NL-04-0715

Joseph M. Farley Nuclear Plant Units 1 and 2  
Application for License Renewal – Requests for Additional Information

**Joseph M. Farley Nuclear Plant Units 1 and 2  
Application for License Renewal  
Responses to March 29, 2004 Requests for Additional Information**

**Joseph M. Farley Nuclear Plant Units 1 and 2  
Application for License Renewal  
Responses to April 1, 2004 Requests for Additional Information**

# EH Fluid System

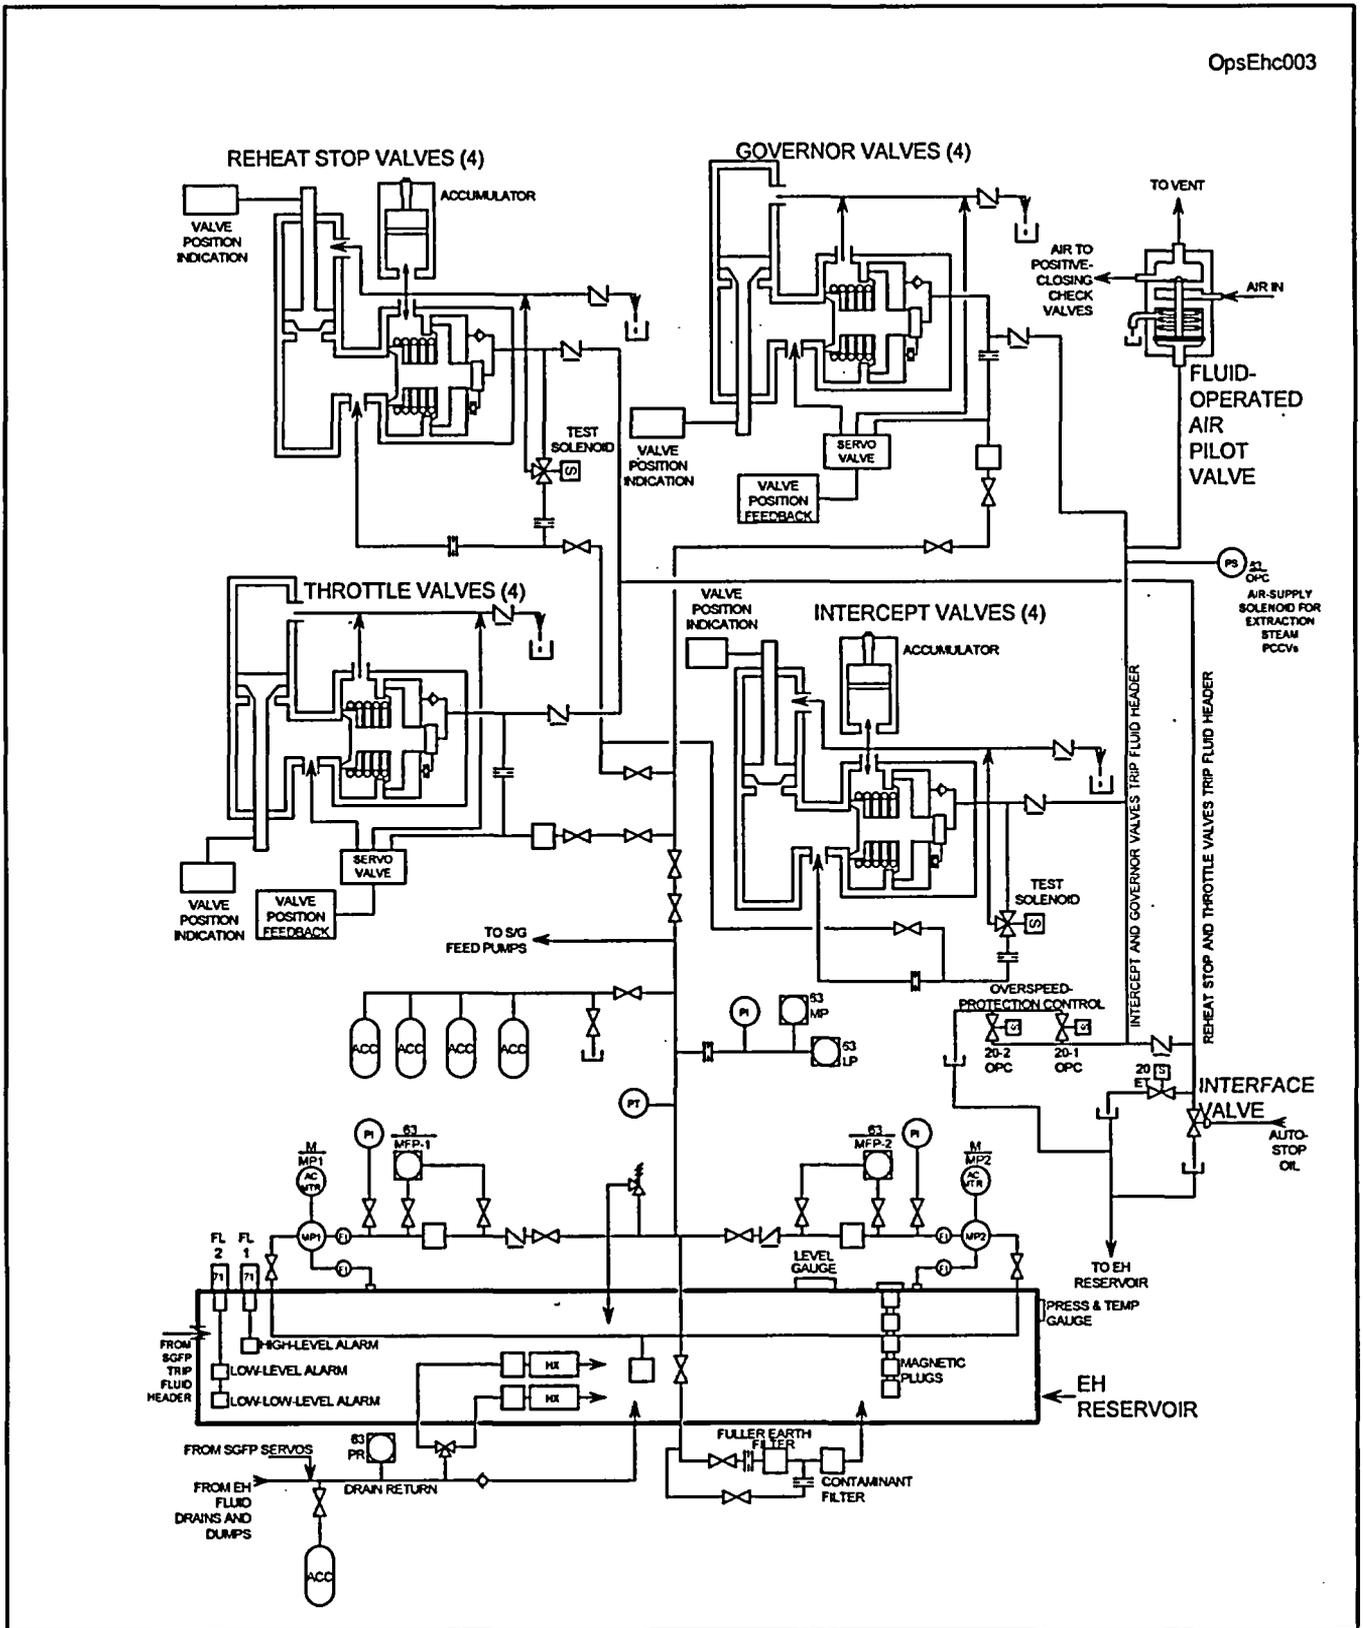
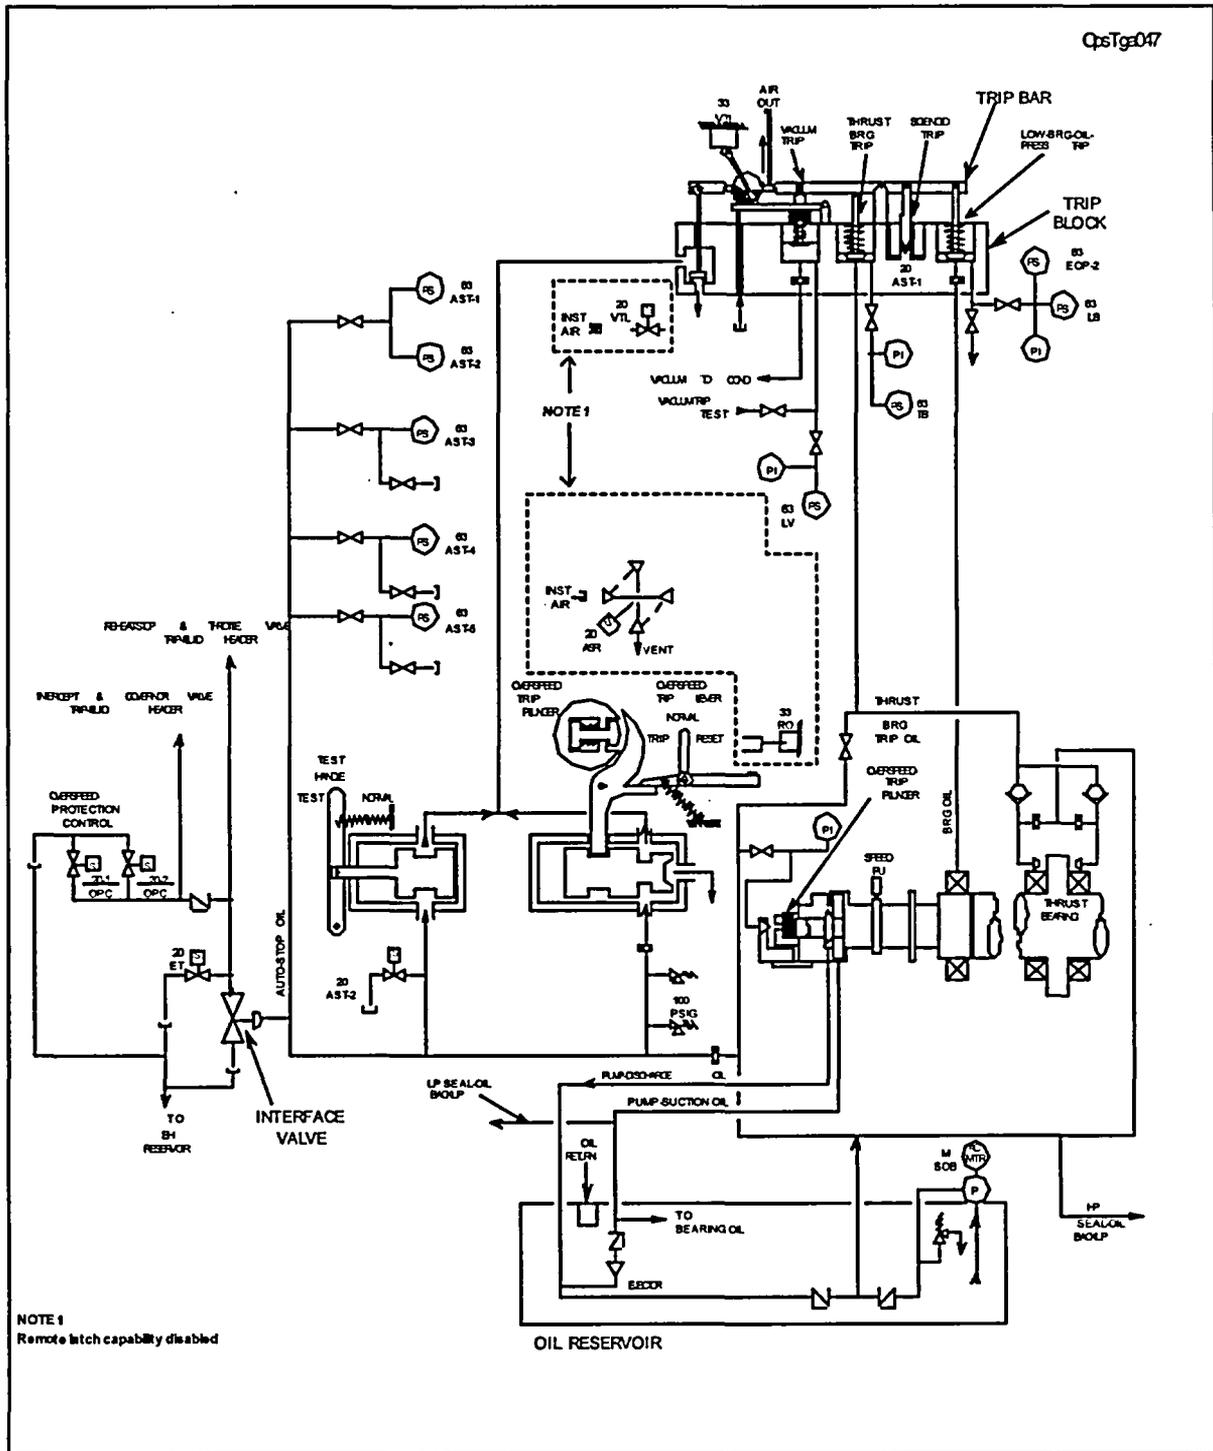
LRA Section 2.3.4.6 states that, in accordance with 10 CFR 54.4 (a)(2), "The non-safety related structures and components (SCs) of the turbine and turbine auxiliaries that are required to trip the turbine in response to an anticipated transient without scram (ATWS) event and in response to a turbine overspeed event are conservatively included in the scope of license renewal for FNP." However, there are no mechanical components of the turbine and turbine auxiliaries system that are identified as being subject to an AMR.

Since LRA Section 2.3.4.6 does not provide or reference any boundary drawings associated with the turbine and turbine auxiliaries system, the staff is unable to confirm your determination that this system does not contain mechanical components subject to an AMR. For the staff to complete its review, provide a description or license renewal boundary drawing that identifies the components of the turbine and turbine auxiliaries system, and that shows which SCs are considered to be within the scope of license renewal in accordance with the requirements of 10 CFR 54.4(a). Justify the exclusion of the mechanical components of this system from being subject to an AMR in accordance with the requirements of 10 CFR 54.21(a)(1).

A description of the turbine trip operation and diagrams from the Operations student lesson plans are provided to assist the staff in completing its review.

A turbine trip is initiated by dropping the fluid header pressure in either of the trip fluid headers (throttle & reheat stop valve trip fluid header and the intercept & governor valve trip fluid header) to a point where the hydraulic pressure is insufficient to overcome valve spring pressure thereby resulting in valve closure and termination of steam flow to the turbine. These trip fluid headers can function independently or together and are affected by the interface valve and by the 20/ET solenoid valve. Opening either the interface valve or 20/ET valve will drop fluid header pressure and close the throttle, reheat stop, intercept, and/or governor valves associated with the main turbine thus tripping the turbine. The turbine trip function is called upon in response to a normal turbine trip, reactor trip, turbine overspeed, and a turbine trip resulting from ATWS.

A review of the turbine controls design and component functions during the mechanical system screening process concluded that the trip functions are performed by active components, and that any passive component failure (loss of pressure boundary) would not prevent the performance of the system intended functions. On the contrary, loss of pressure boundary in the electrohydraulic (EH) Fluid or Auto Stop Oil subsystems would initiate a turbine trip, not prevent one. Therefore, the screening review concluded that the passive turbine controls components do not perform any intended functions for license renewal as described in 10 CFR 54.21(a)(1); therefore, none of the Turbine and Turbine Auxiliaries LRA system components are subject to an aging management review. Note that similar determinations by prior applicants (e.g., Robinson Nuclear Plant, Virgil C. Summer Nuclear Station) have been accepted by the staff.
